2020-07 BAR Decision for 411 1st Street North

BAR 20-07-06

411 1st Street N

City of Charlottesville
Board of Architectural Review
Staff Report
July 21, 2020

Front Elevation
SCALE: 3/16" = 1'-0" 1

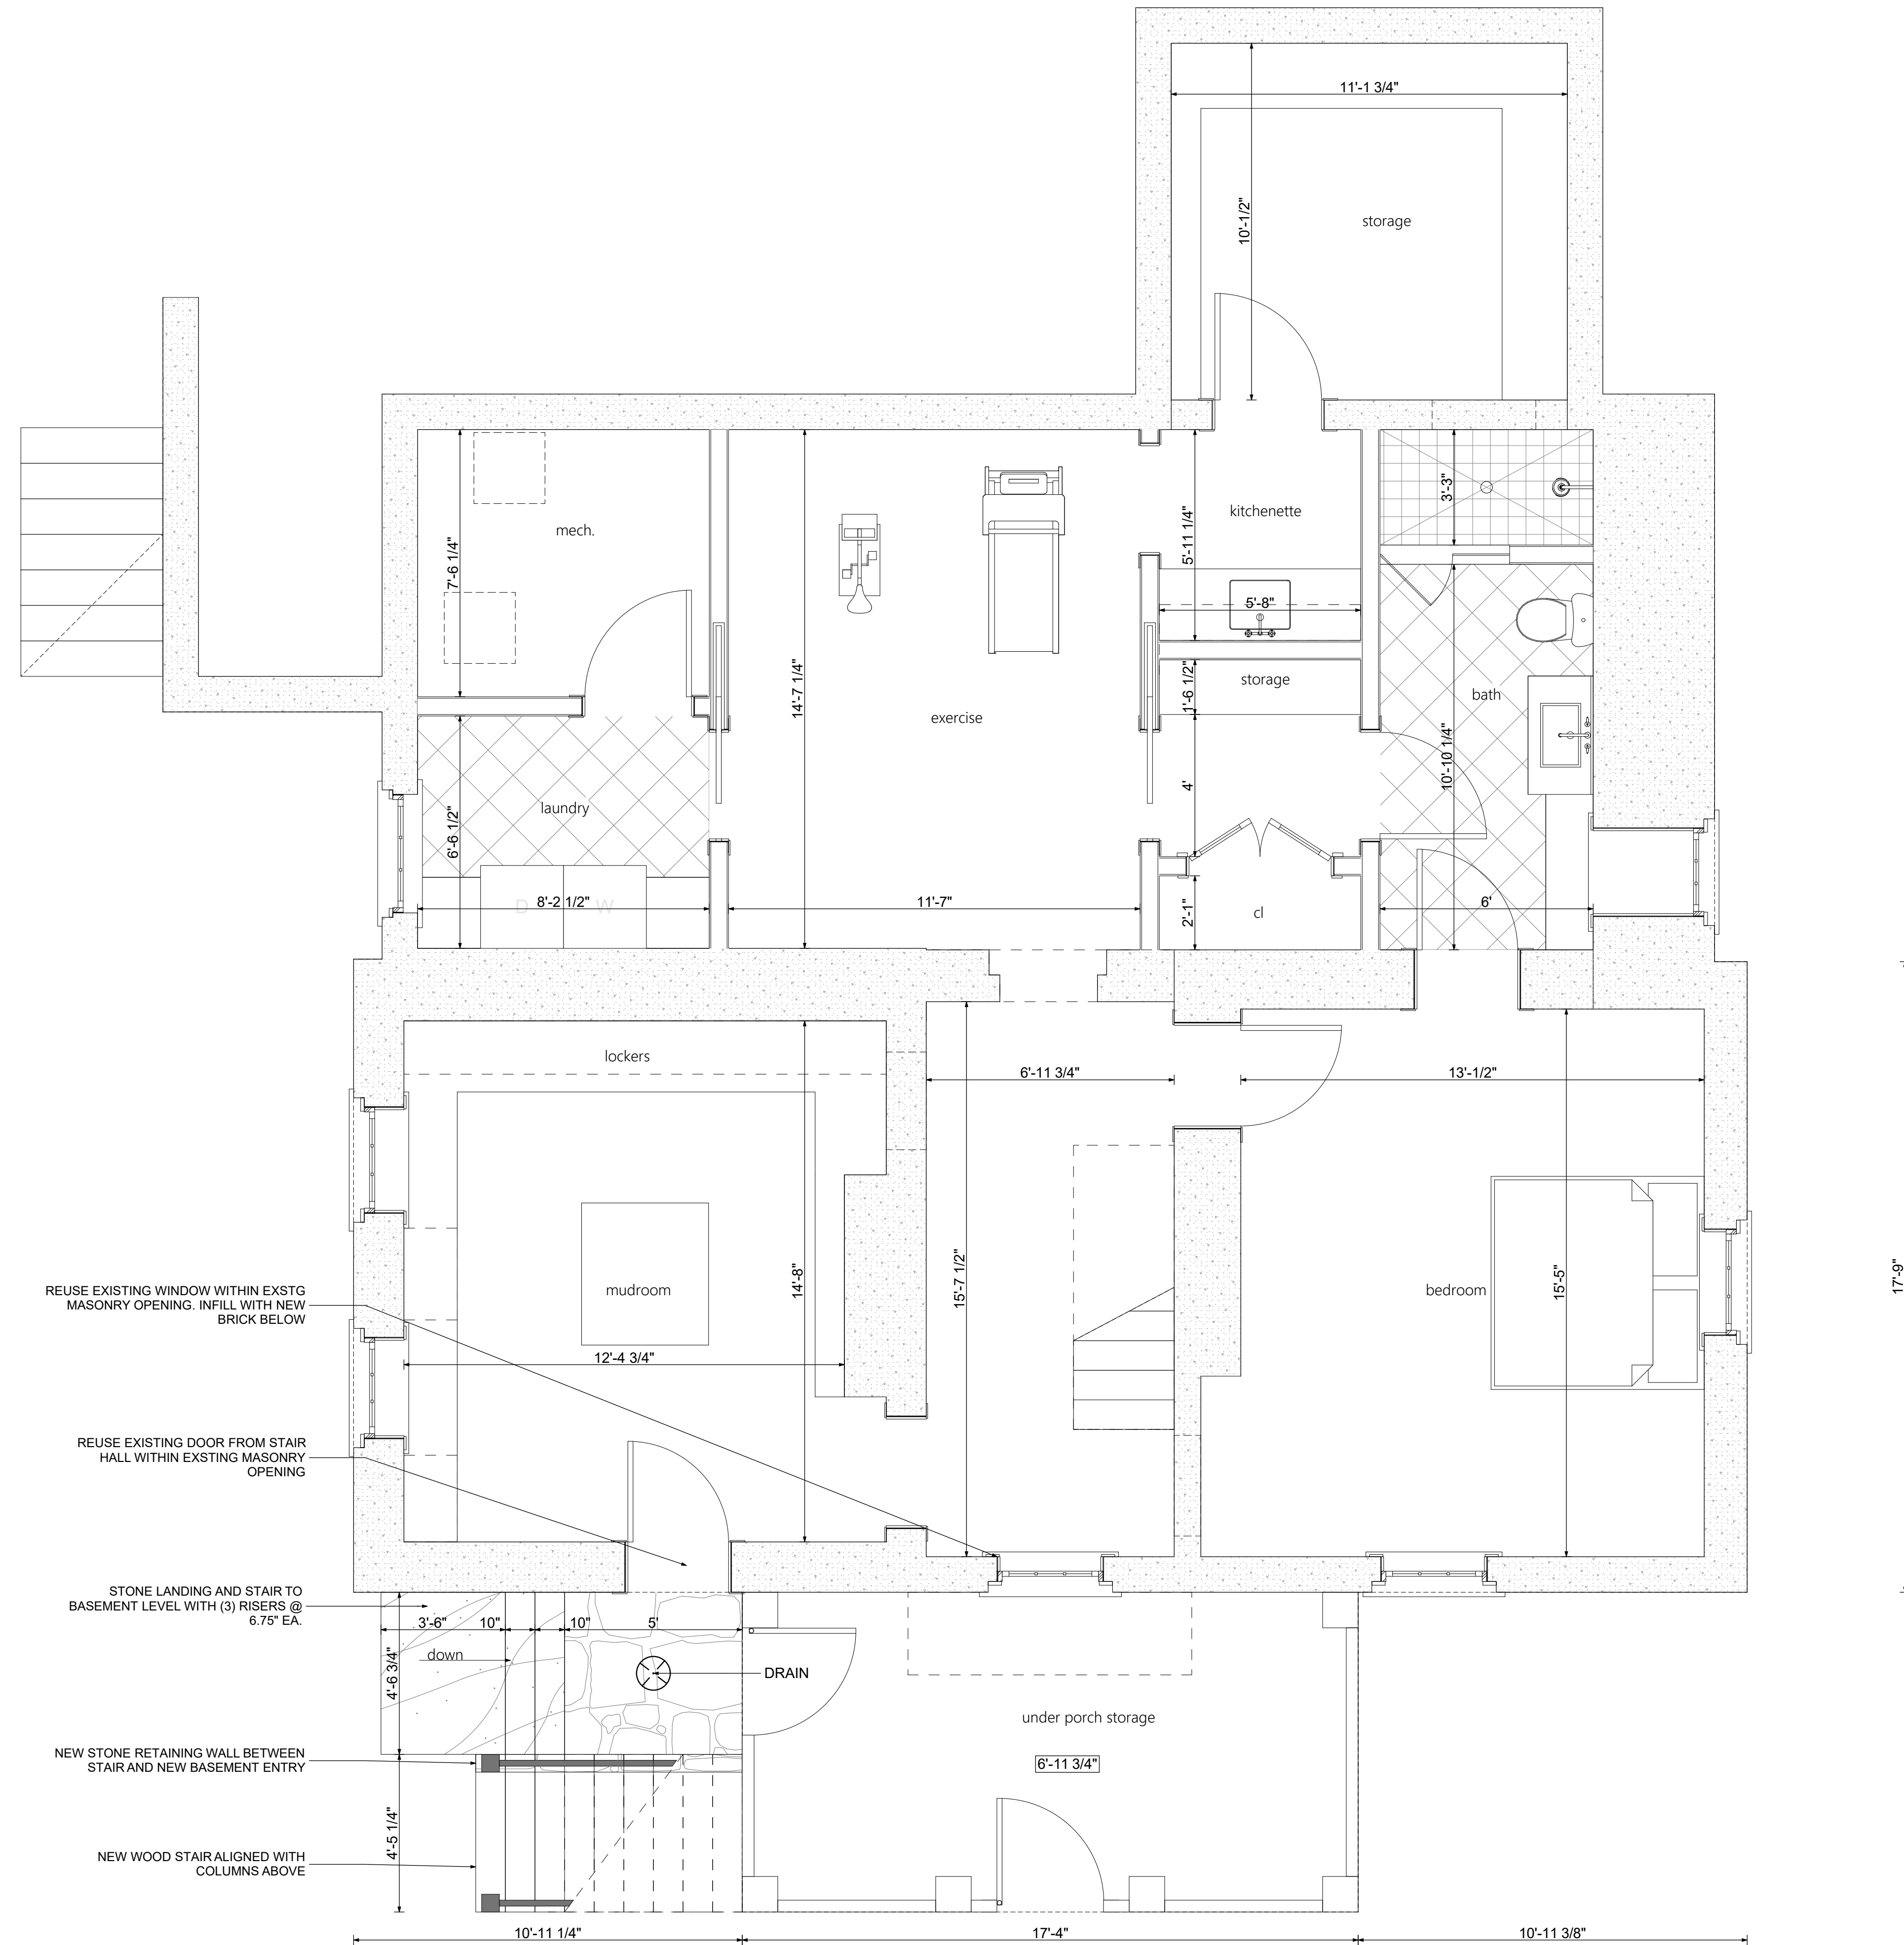
Note: While the drawings indicate swapping the existing window with the existing door, the applicant would prefer to leave the door in place and install a new door in the window opening.

- [Staff concurs with the applicant's preference.] Remove only the proposed window and install a new door in the opening. Leave in place the existing door at the center, below the front porch.
- Retain and store the existing window, should the opening be later restored.
- The existing masonry opening is not altered other than below the existing window.
- For the exterior light fixture, the lamping will have a Color Temperature not to exceed 3,000K, preferably dimmable, and will comply with the City's "Dark Sky" ordinance.
- Applicant will provide to staff for the BAR archive cut sheets for the doors, windows, and any exterior light fixtures.

- Leave in place the existing door at the center, below the front porch.
- Retain and store the existing window, should the opening be later restored.
- The existing masonry opening is not altered other than below the existing window.
- For the exterior light fixture, the lamping will have a Color Temperature not to exceed 3,000K, preferably dimmable, and will comply with the City's "Dark Sky" ordinance.
- Applicant will provide to staff for the BAR archive cutsheets for the doors, windows, and any exterior light fixtures.
- That a half-lite aluminum-clad solid wood door be used.
